ADDENDUM #3

Project	Holy Family Catholic Elementary School	Project No.	2325
Location	1420 Grosvenor Street, Oakville, ON	Date of Issue	2024 04 09
Owner	Halton Catholic District School Board	File	2325/7.1.3

RE: Holy Family Catholic Elementary School
Renovations
Oakville, ON

ADDENDUM 02

Drawing Title
GROUND FLOOR PLAN RENOVATION PHASE 2
Scale: AS NOTED
Drawn by: CP
Job No: 2325
Date:
Checked by: MEK
Drawing No: E32

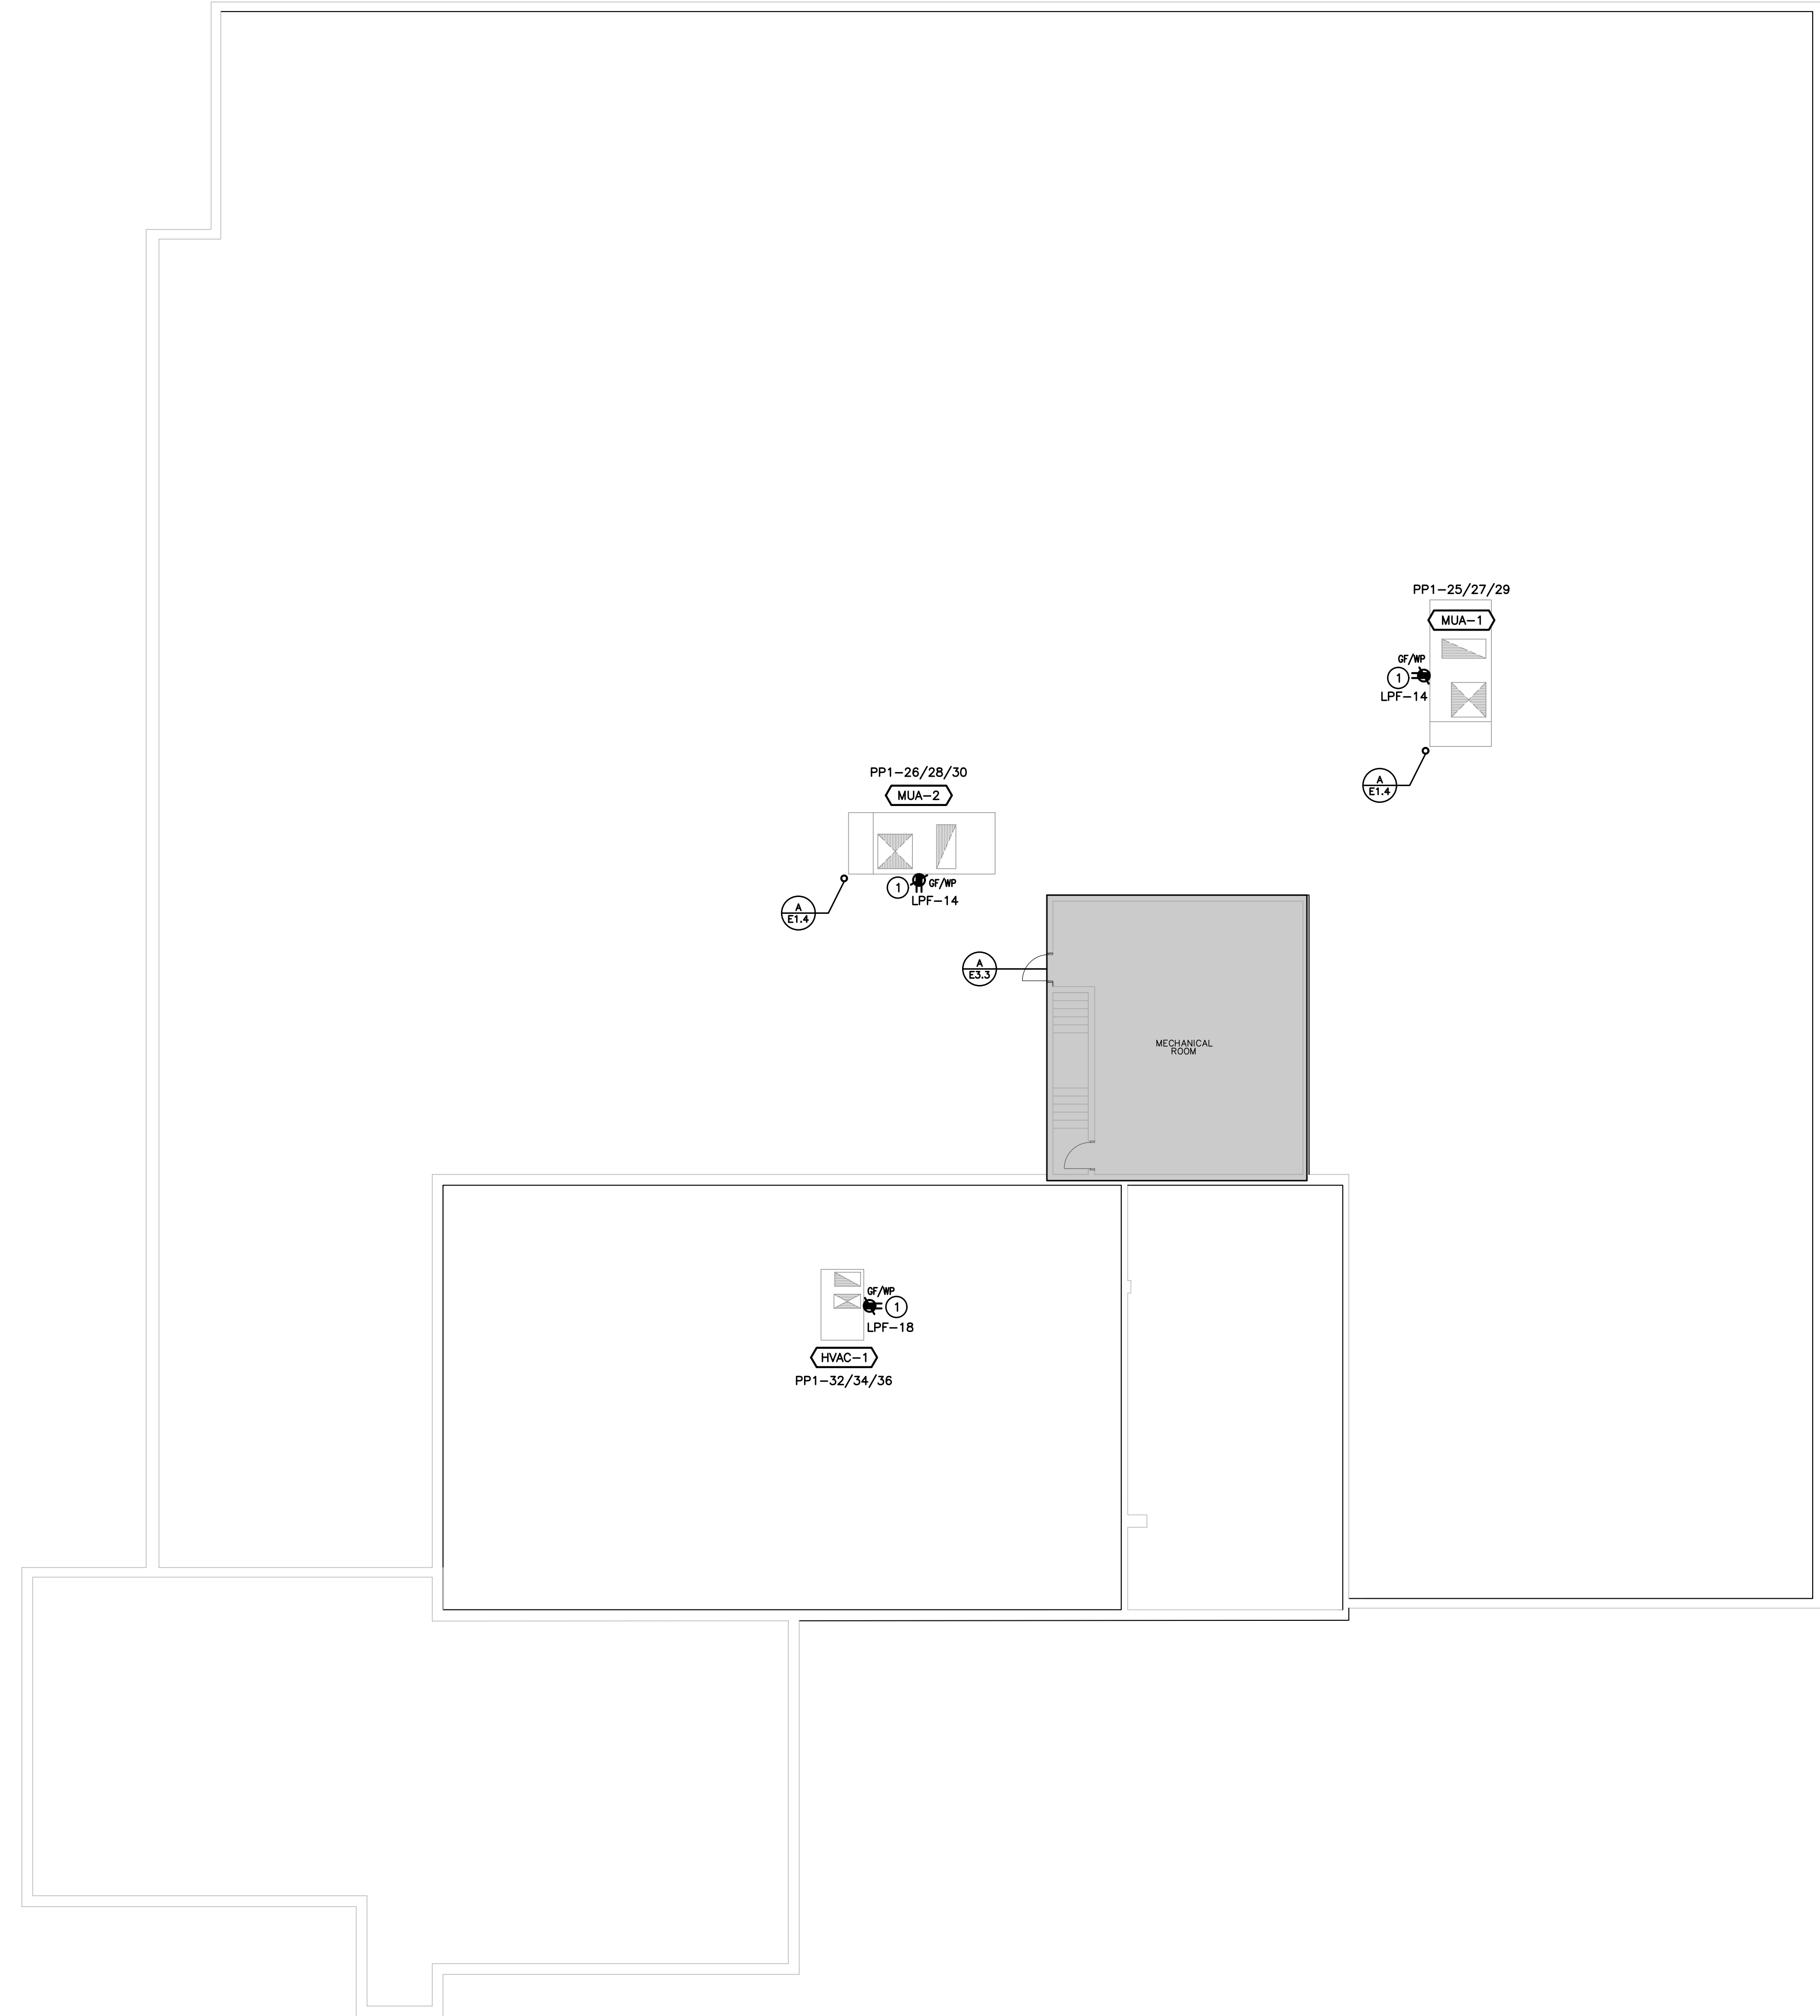
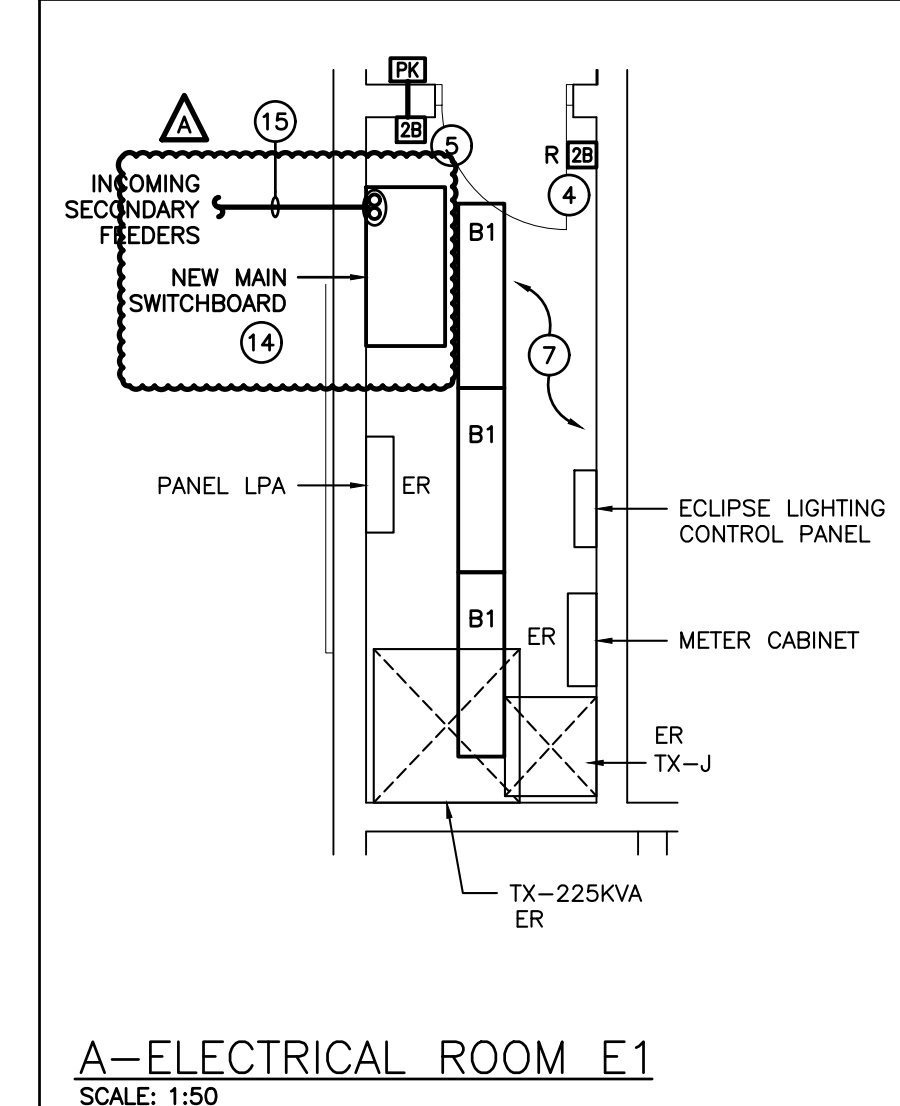
9.0 Reference Attached Reissued Drawing E3.2

- .1 Indicate new main switchboard with incoming secondary feeders within electrical room as shown. Revise Note 14 to suit.

- 13 FEED INDICATED DEVICE USING SURFACE METAL RACEWAY EQUAL TO WIREMOLD SERIES 700.
- 14 REFER TO DISTRIBUTION RISER DIAGRAM FOR REPLACEMENT MAIN SWITCHBOARD.

- 15 INDICATES INCOMING SECONDARY DUCTS FROM EXTERIOR PADMOUNT TRANSFORMER. REFER TO SITE PLAN AND DISTRIBUTION RISER DIAGRAM FOR ADDITIONAL INFORMATION.

ROOF PLAN RENOVATION PHASE 2

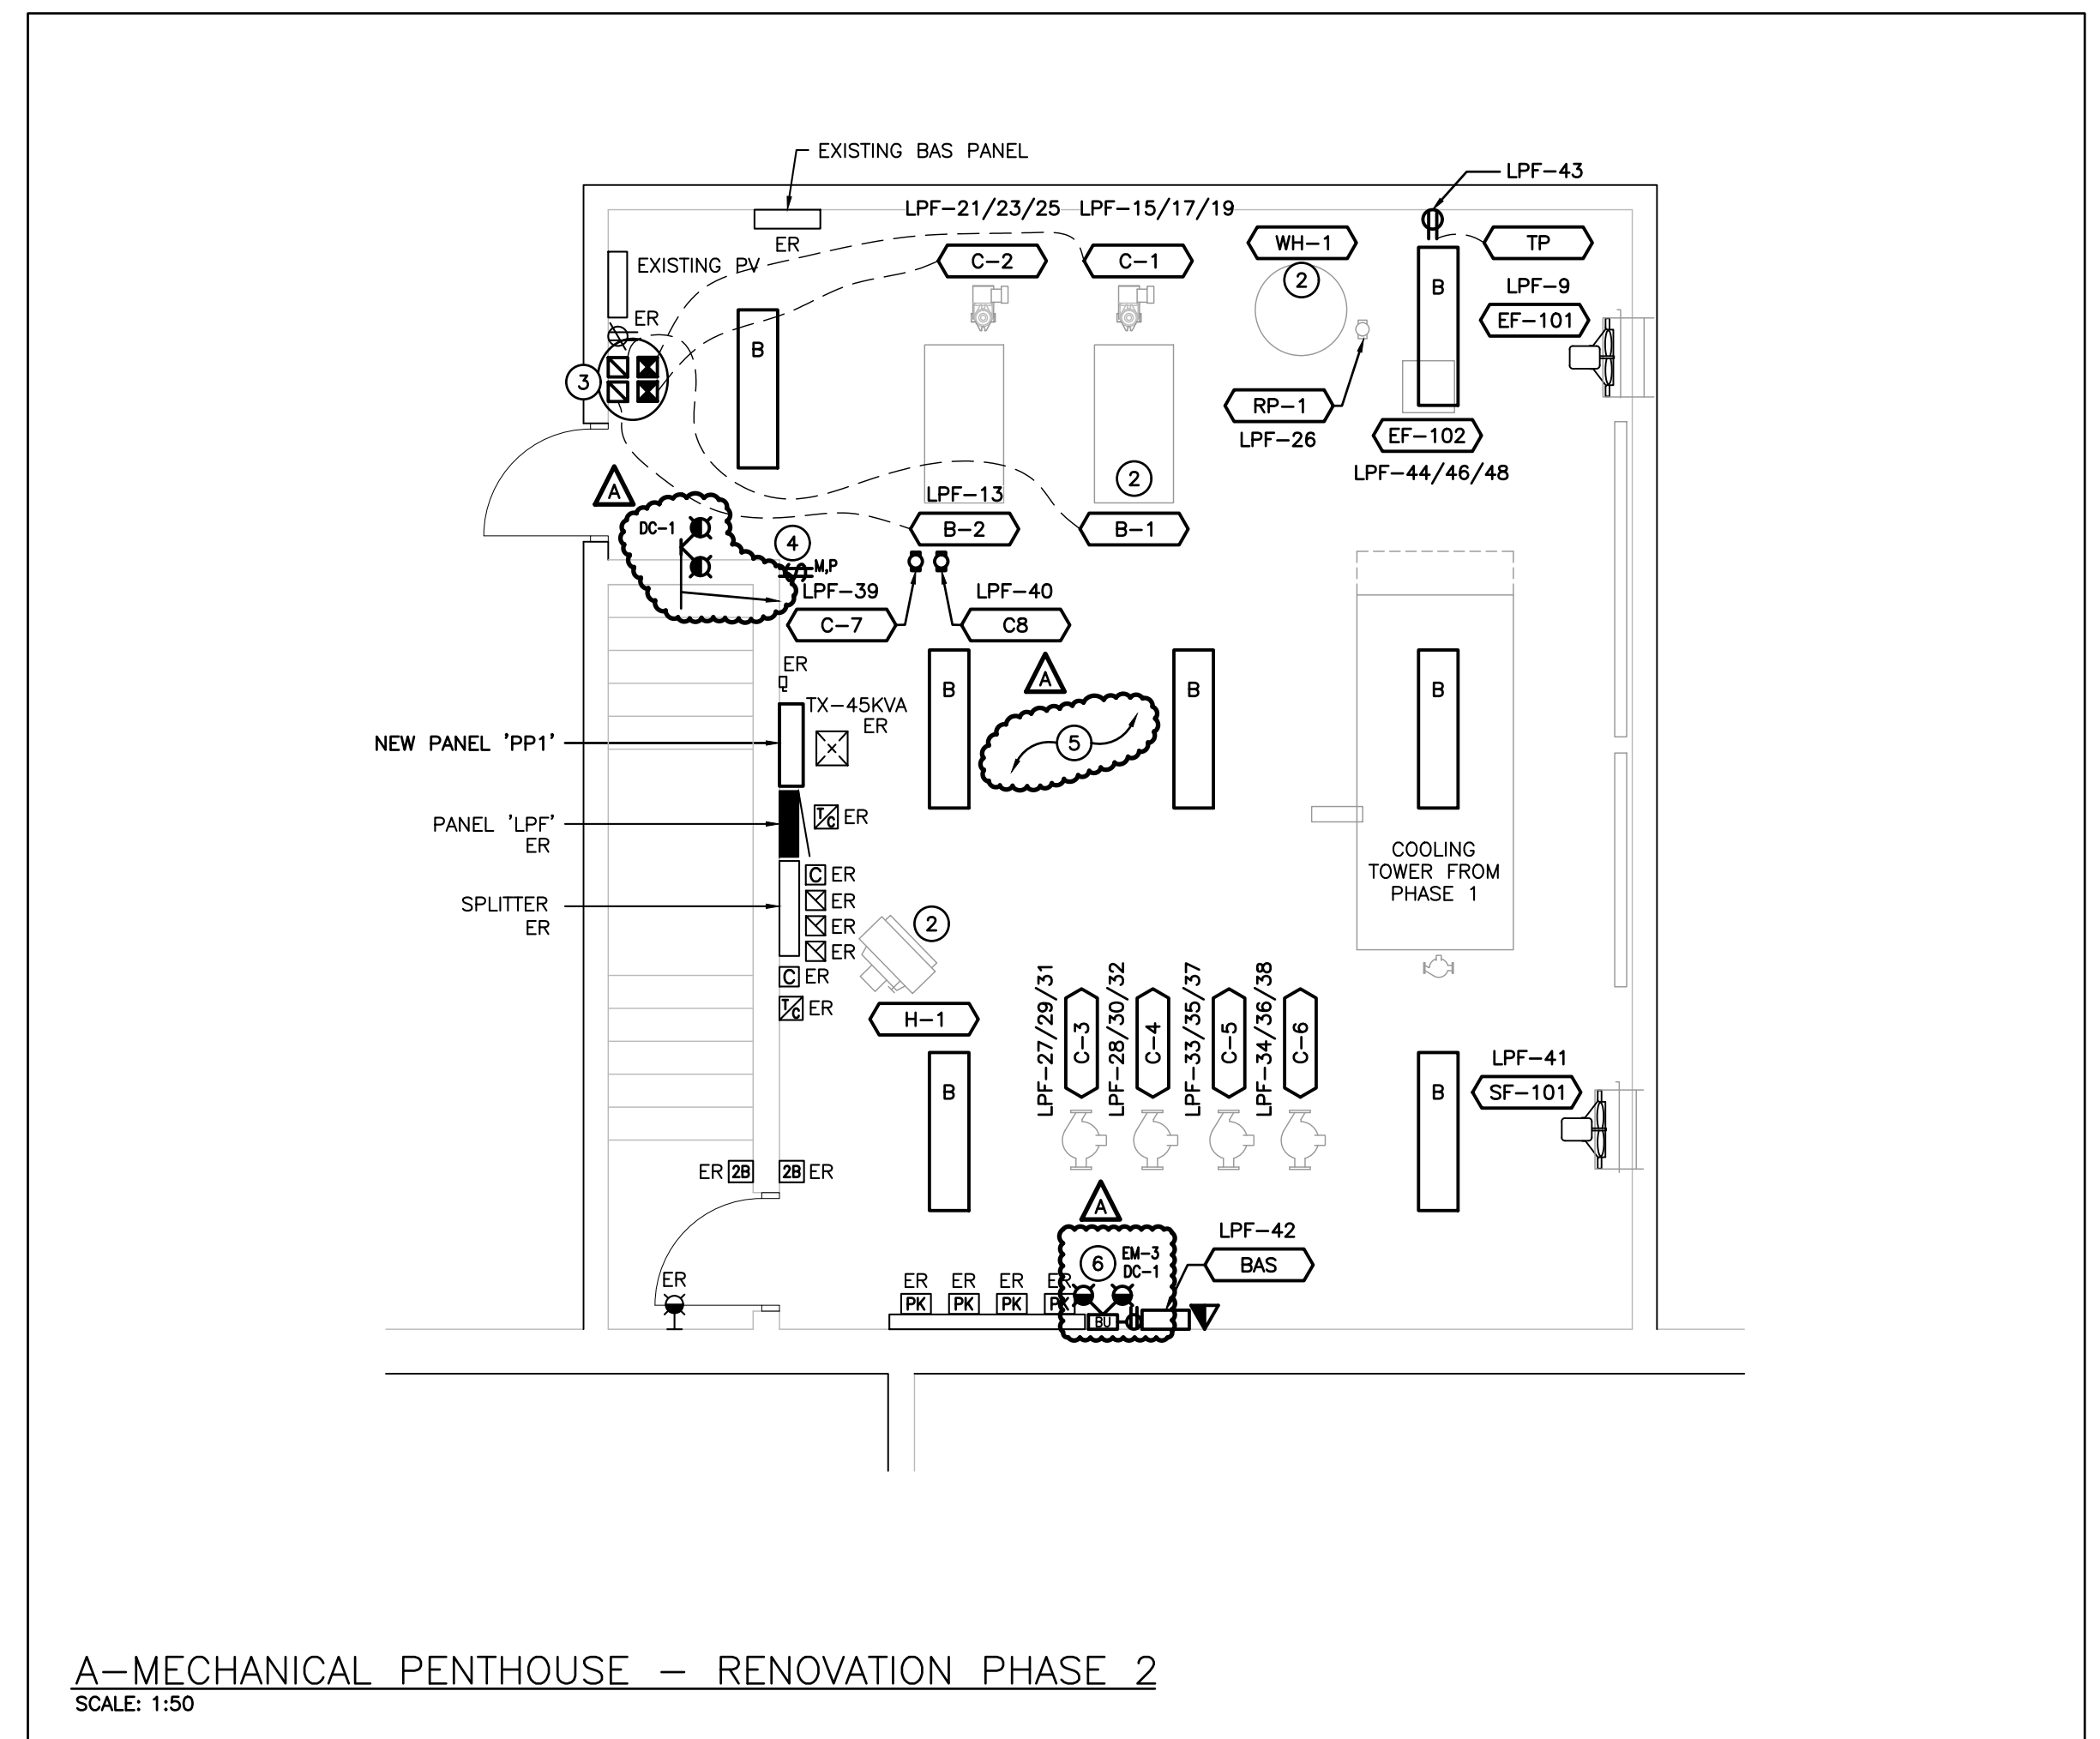
10.0 Reference Attached Reissued Drawing E3.3

- .1 Lighting within mechanical penthouse are to be connected to existing circuit and controls made available during demolition. Add Note 5 to suit.
- .2 Provide emergency battery with remote heads within mechanical penthouse as shown. Add Note 6 to suit.
- .3 Provide additional remote head along west side wall with circuit as shown.
